Date: September 13, 2023  
To: All Vendors  
Subject: Addendum #1

**REFERENCE: P066-23 RE-SOLICITATION OF 15KV METAL CLAD SWITCHGEAR  
FOR THE WATER PORT & LOMA ALTA SUBSTATIONS**

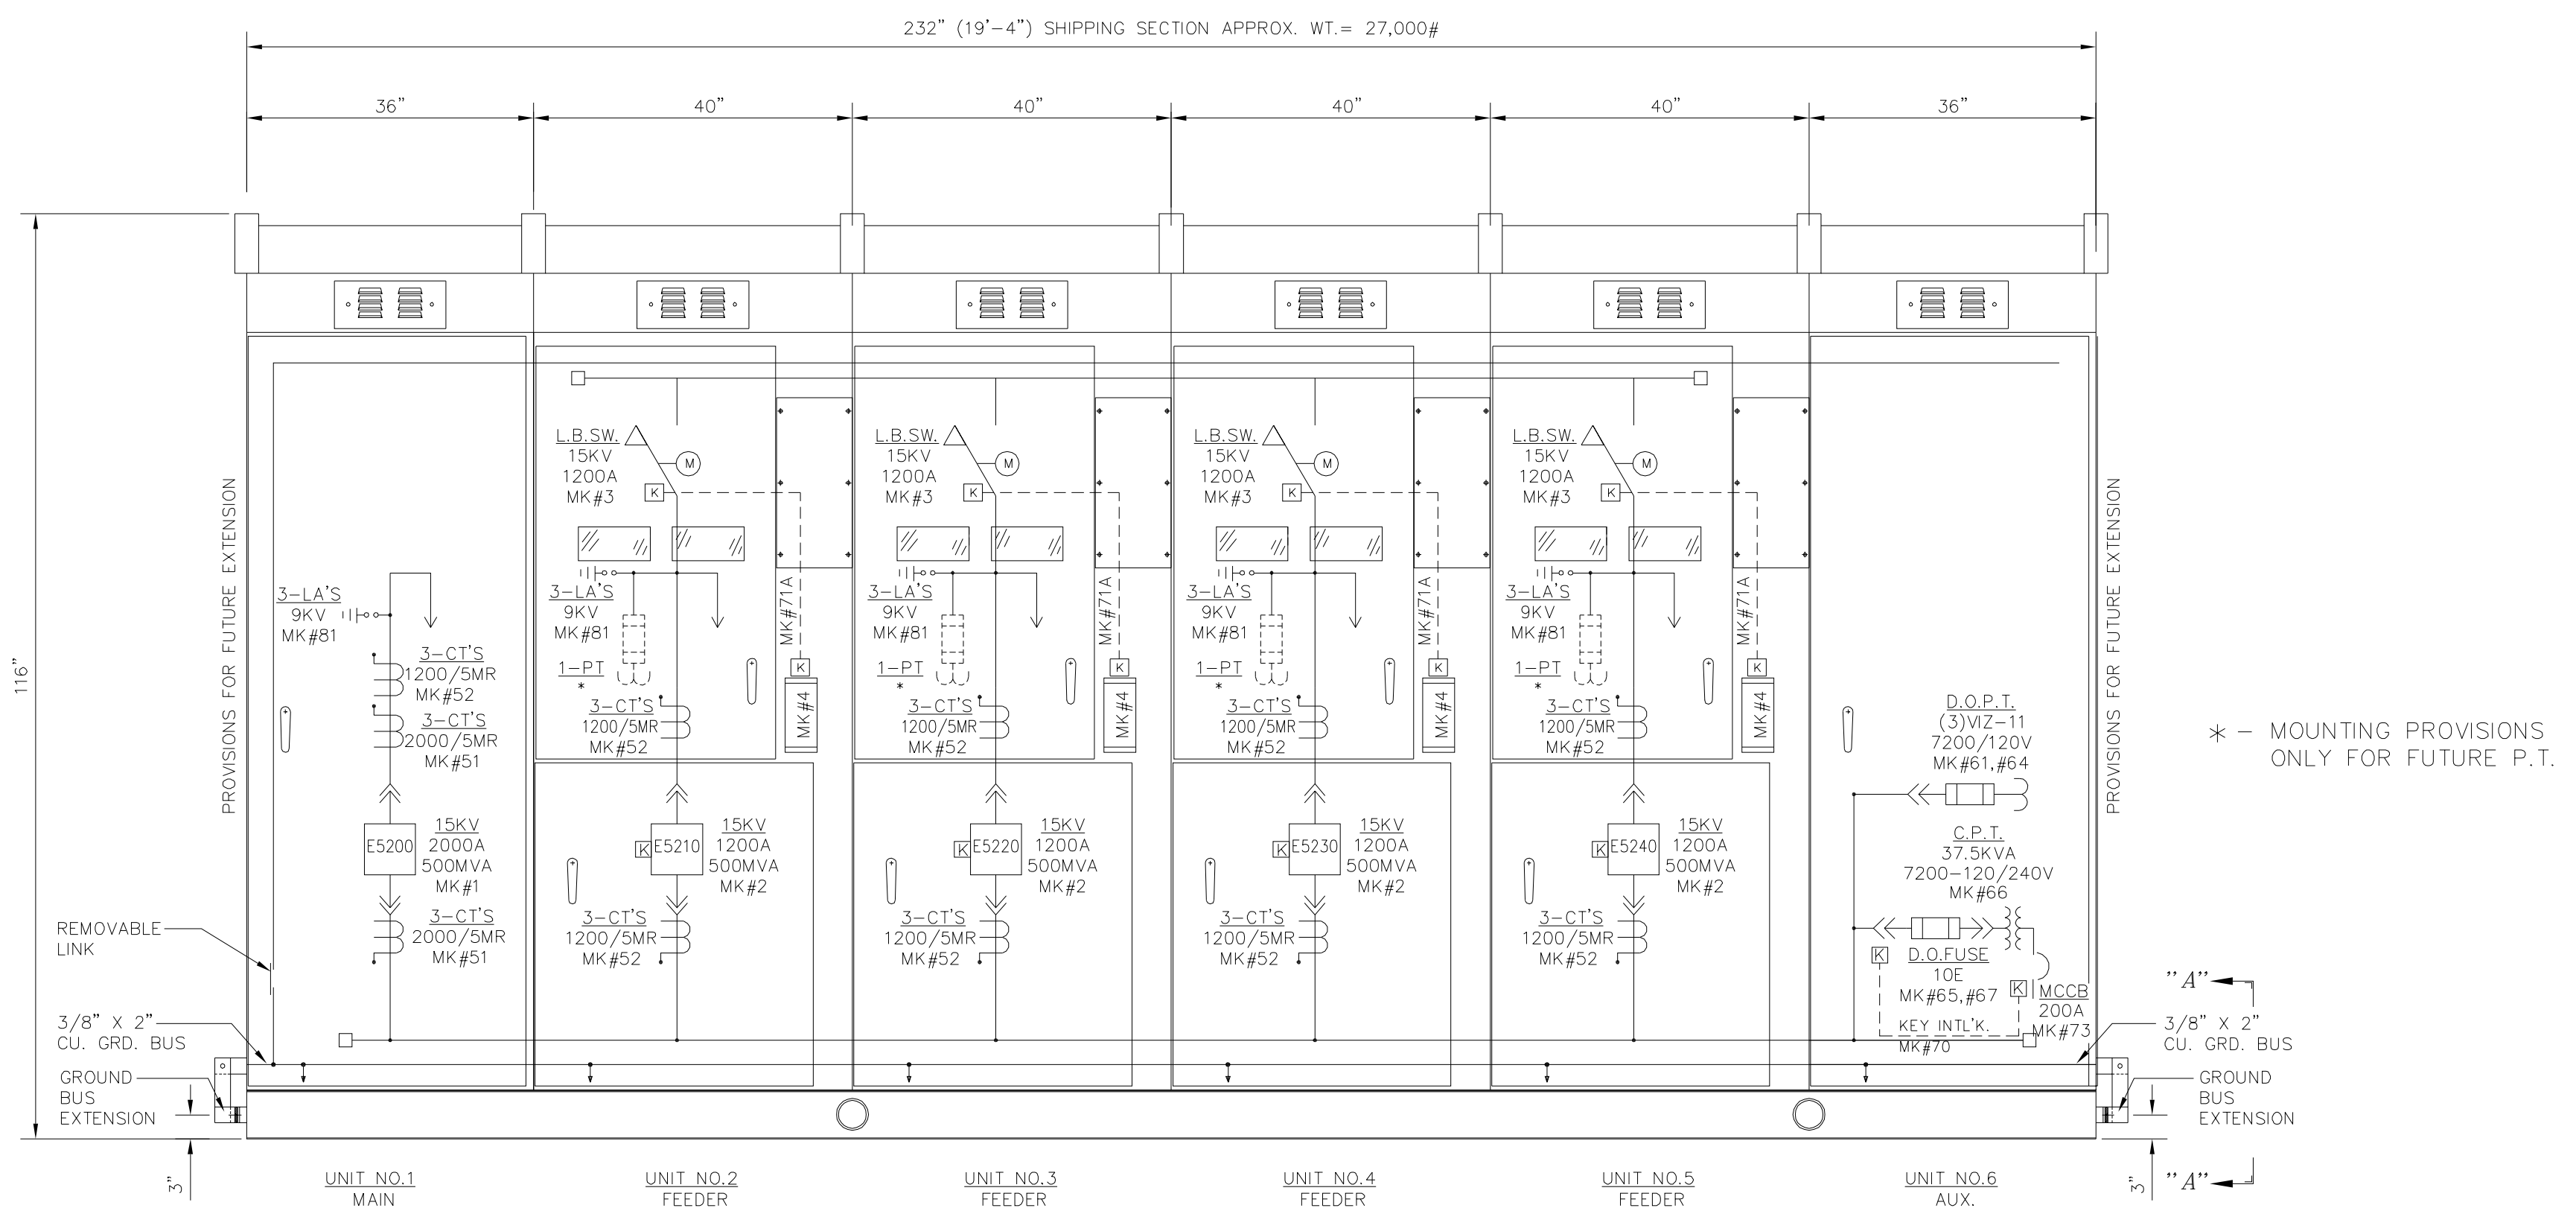
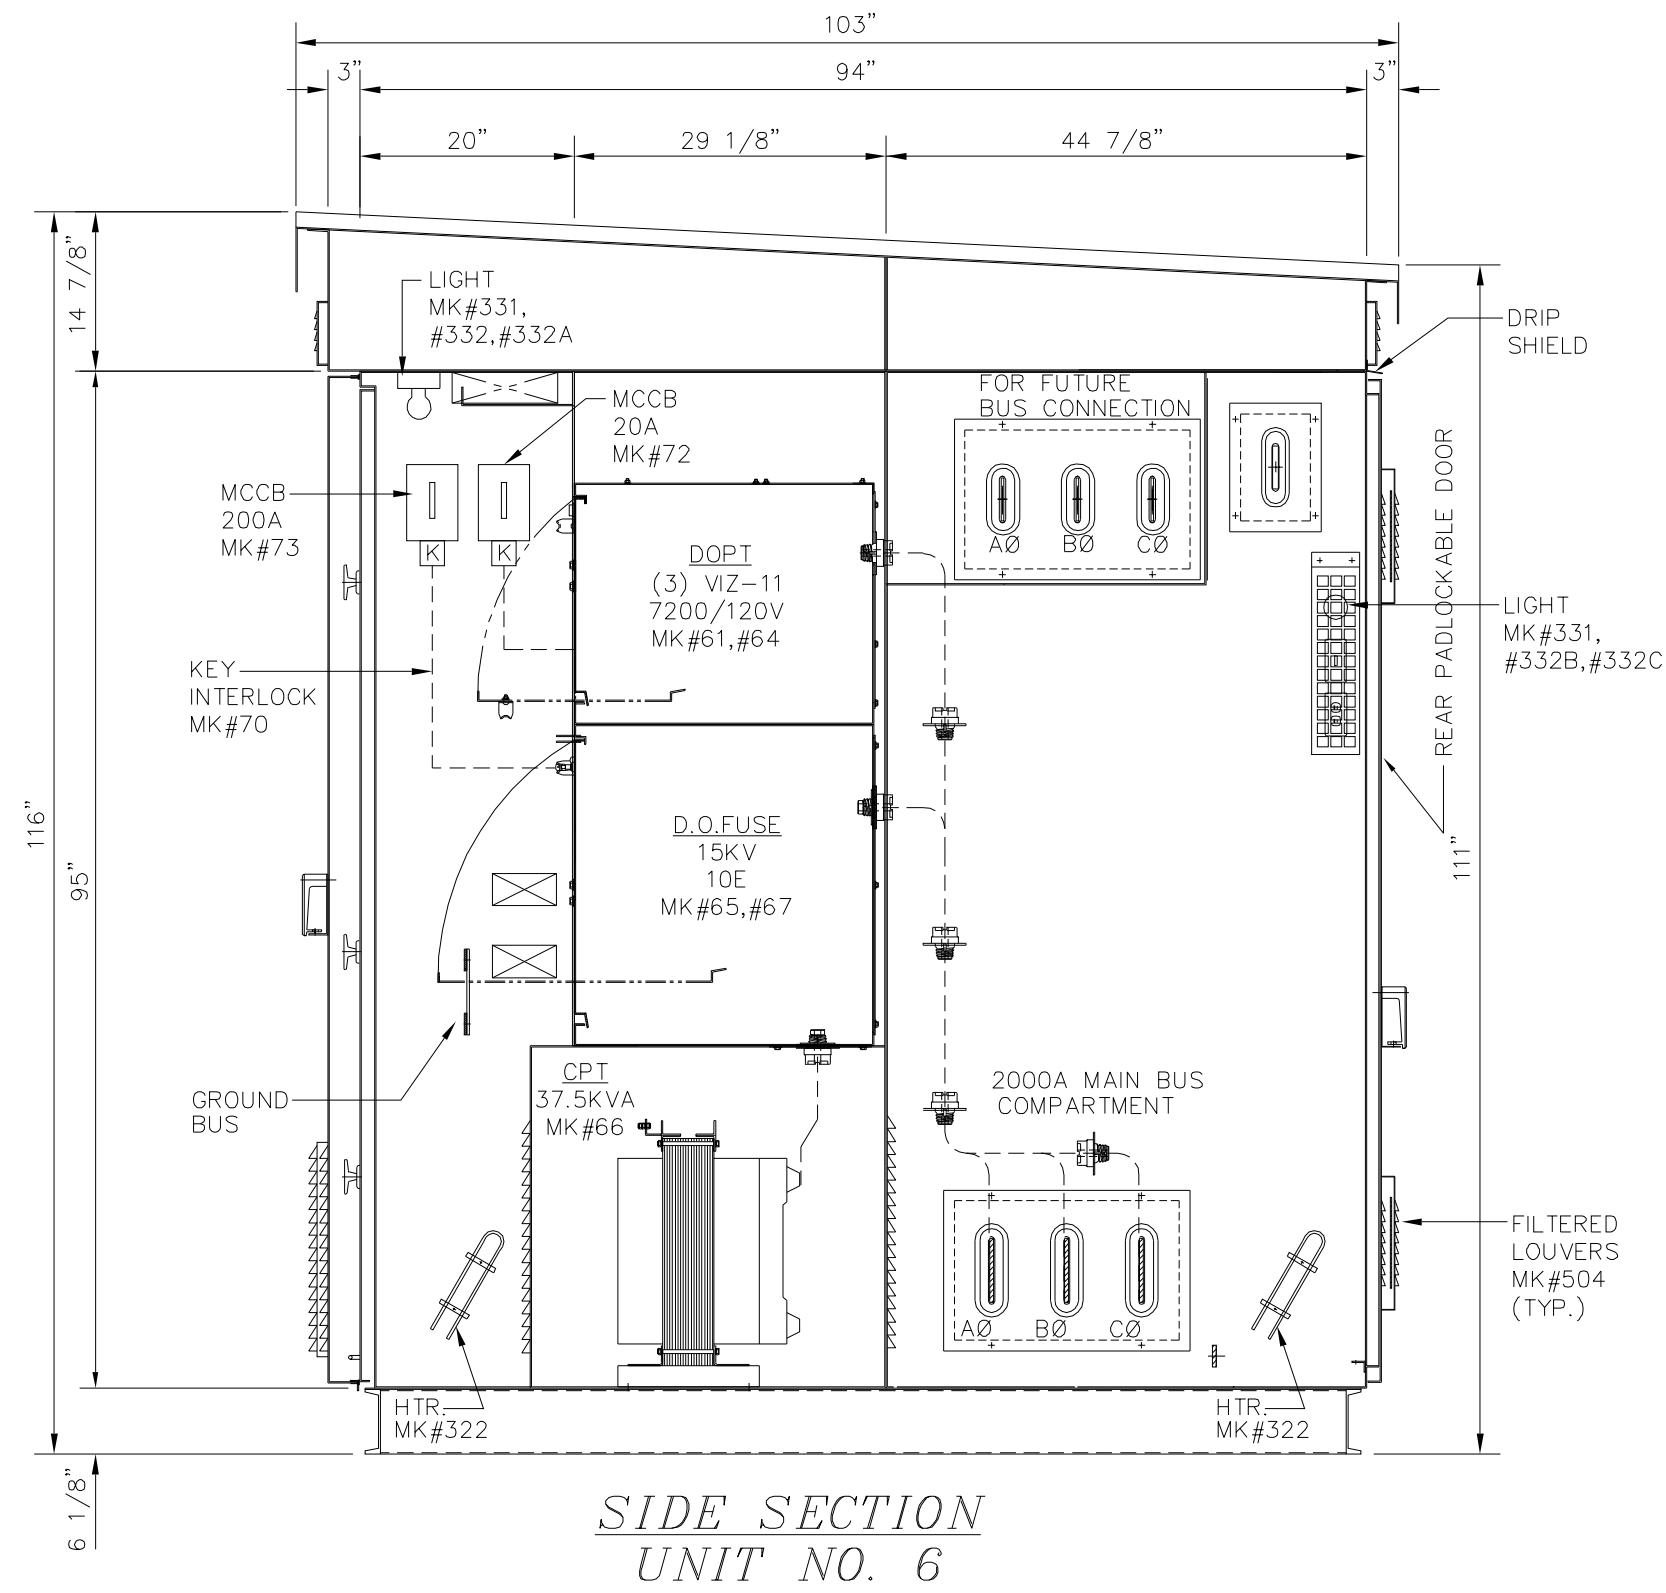
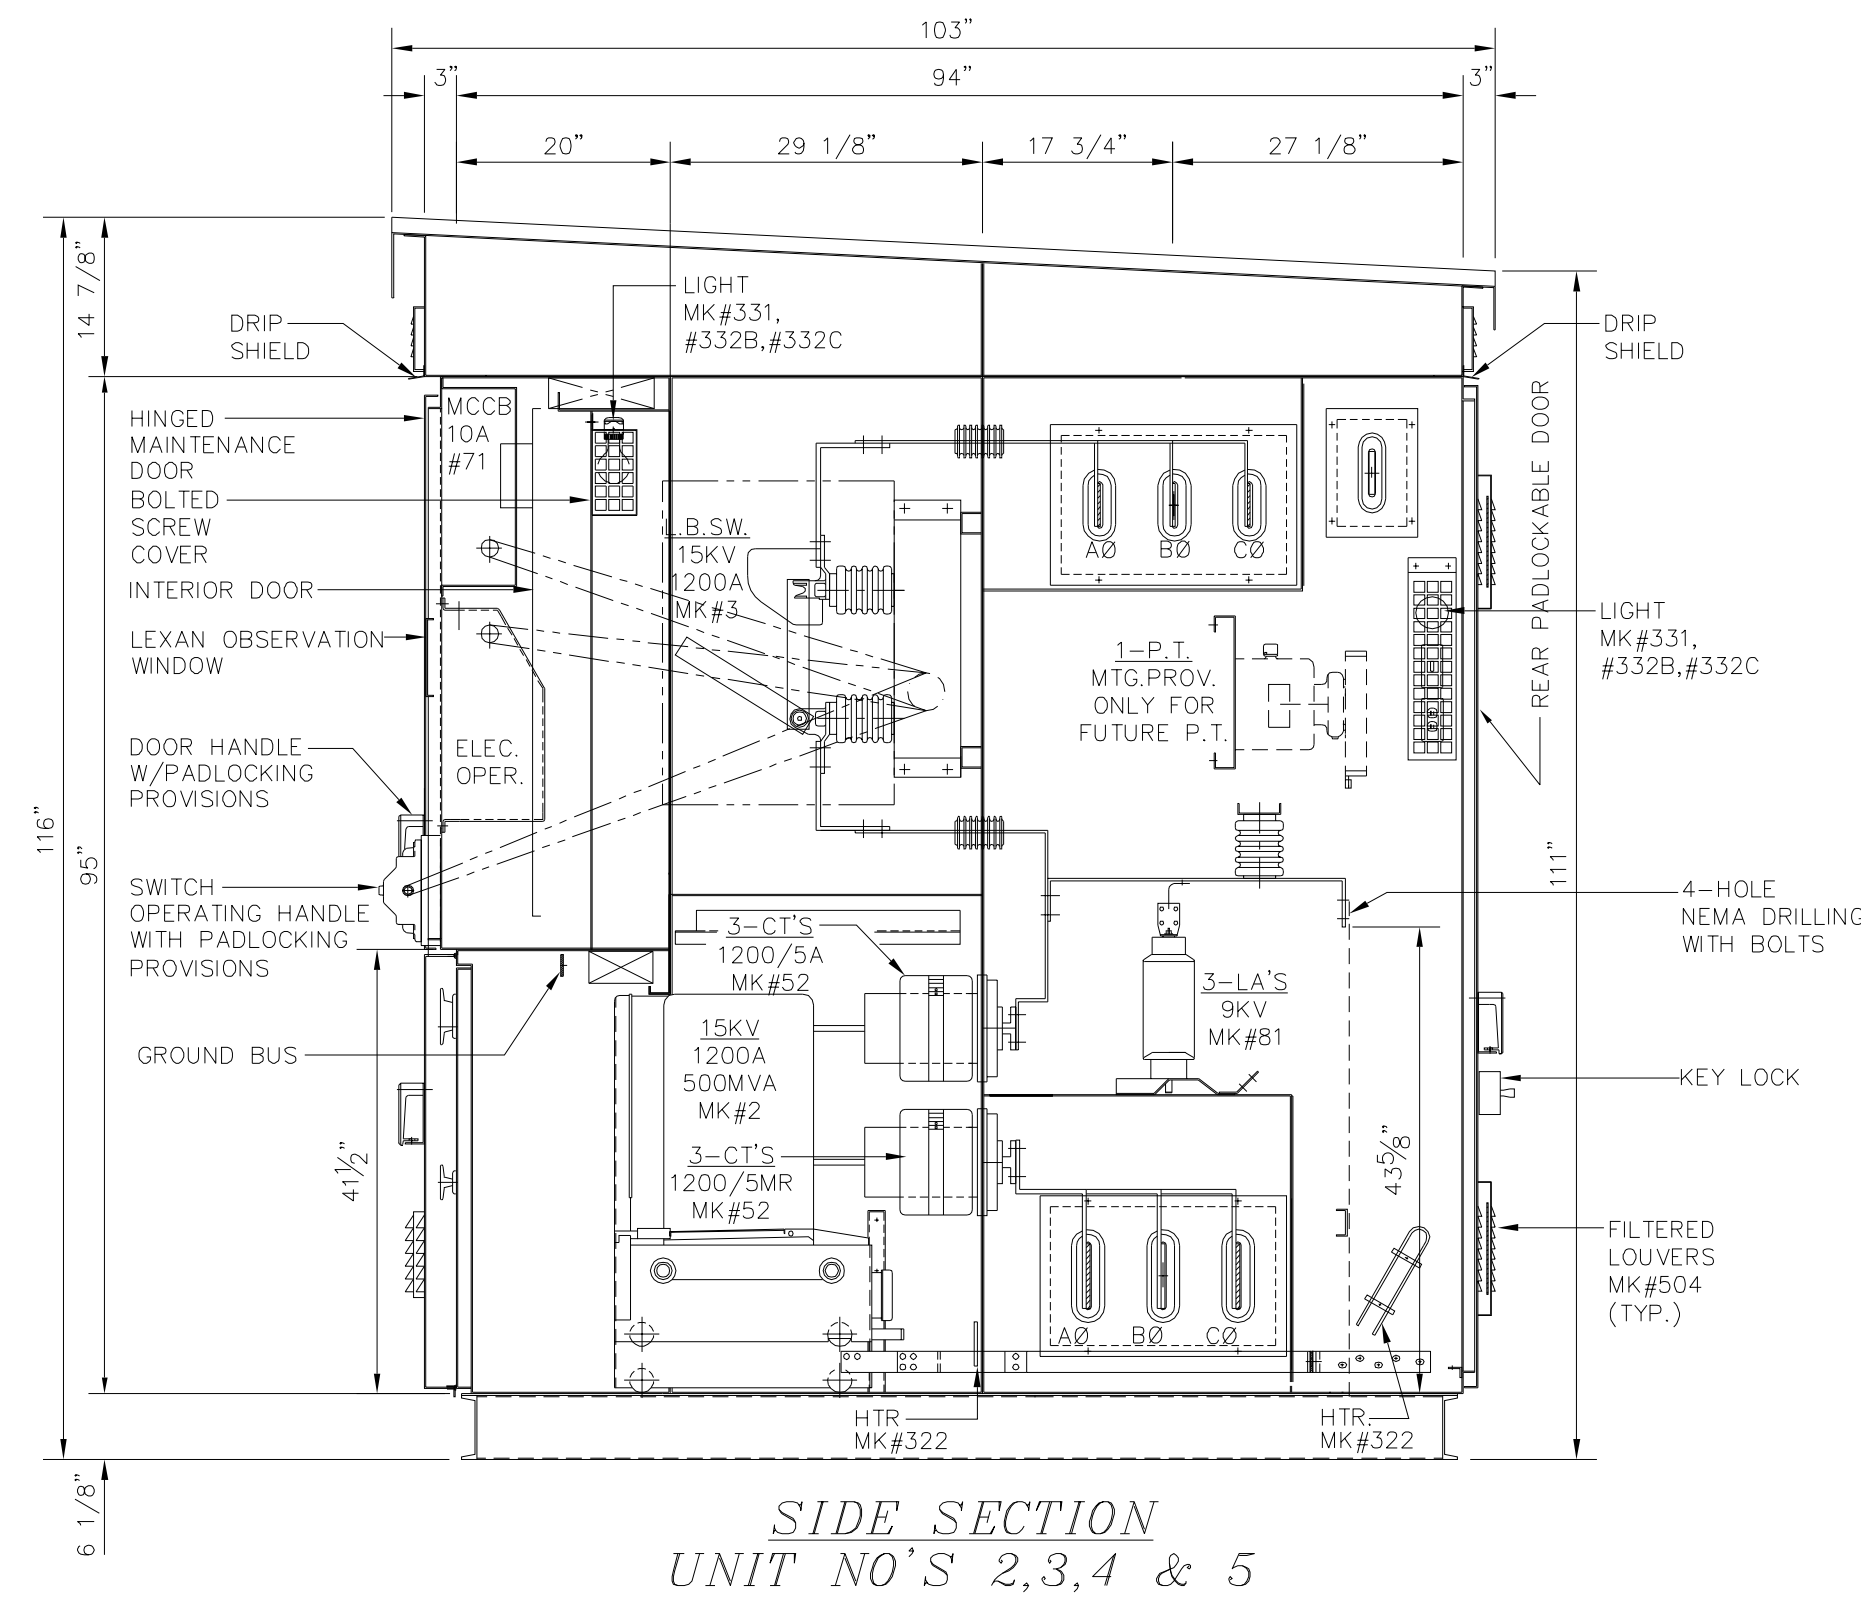
**Question 4:** Would you be able to confirm which type of switchgear you currently have on your system? Will there be a pre-bid site walk that we can attend?

- c) Will these line-ups need to be delivered at the same time or what is the allowable time between deliveries?
- d) The specifications state, these line-ups will need to mate and connect up to existing gear and match the existing foundations. If this is still the case, is there any information on the existing items?

**Answer 4:** Existing Water Port equipment is a 6 cubicle, 15 kV outdoor non-walk in metal-clad switchgear. Refer to attachment "Water Port Substation - Existing Metal-Clad Switchgear (6 Cubicle)". There is no Pre-bid site walk through for this RFP.

- a) The requested 15 kV outdoor non-walk in metal-clad switchgear lineup consists of seven vertical sections (cubicles). Refer to drawing 1003-D-1030A.
- b) Refer to answer for question #6 below.
- c) Refer to answer for question #1 above.
- d) Refer to attachment “Water Port Substation - Existing Metal-Clad Switchgear (6 Cubicle)” and “P06623 WP\_021O\_(1003-D-1024)”.
